Planning and Zoning Commission- Regular Meeting AGENDA

Monday, June 08, 2020 at 5:30 PM
Ketchum City Hall
480 East Avenue North, Ketchum, ID 83340

- 8. ACTION - 4th & Main St Mixed-Use Building Pre-Application Design Review:** Main Street between 4th and 5th Streets (Ketchum Townsite: Block 5: Lots 1, 2, 3, and 4.) The Commission will consider and give direction on a Pre-Application Design Review submitted by Chris Ensign of Solstice Homes Development for a new four-story, 47.5 foot tall, 59,130-square-foot mixed-use building located on four lots on Main Street between 4th and 5th Streets within the Retail core of the Community Core (CC-1). *Continued from March 9, 2020.*

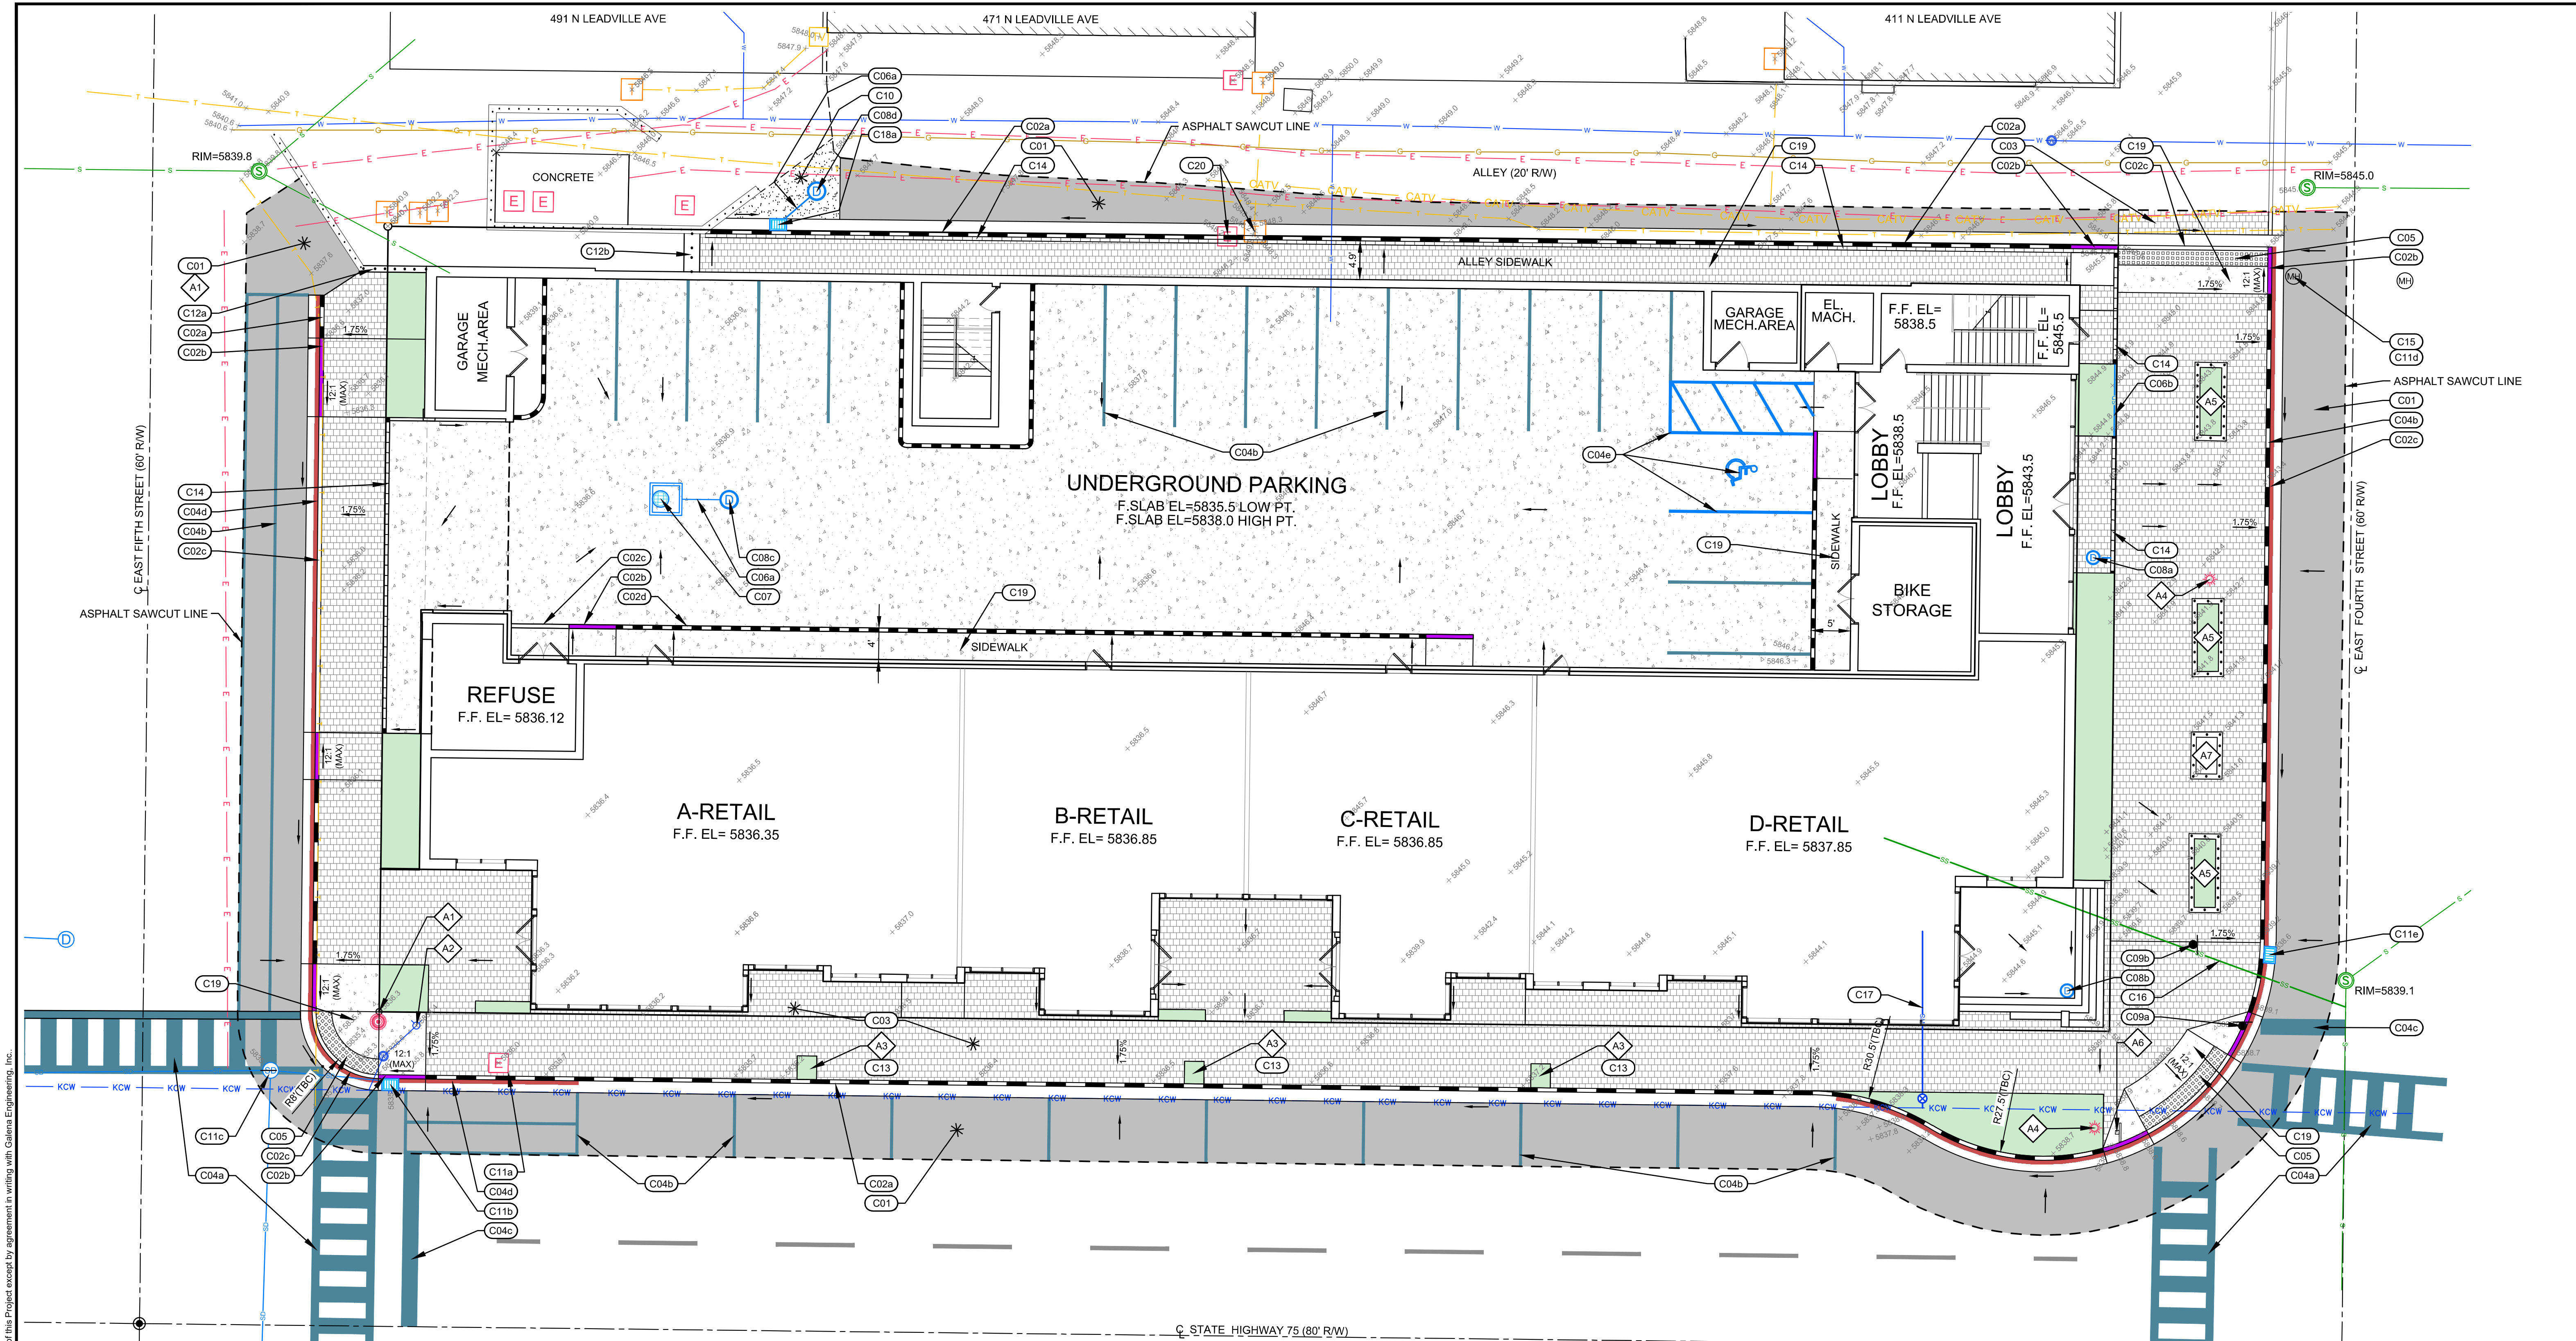
The site plan (Sheet C1.0) indicates three parking spaces, including the ADA space, that appear to require backing out onto 5th Street. The Design Review application should include a diagram illustrating circulation within the underground parking garage and vehicles exiting onto 5th Street.

The refuse building is located within the building adjacent to the parking garage access along 5th Street (Sheet C1.). The trash disposal area must be adequately sized for both trash and recycling for the entire building, including the commercial retail spaces. The developer must submit a will-serve letter from Clear Creek Disposal with the final Design Review application.
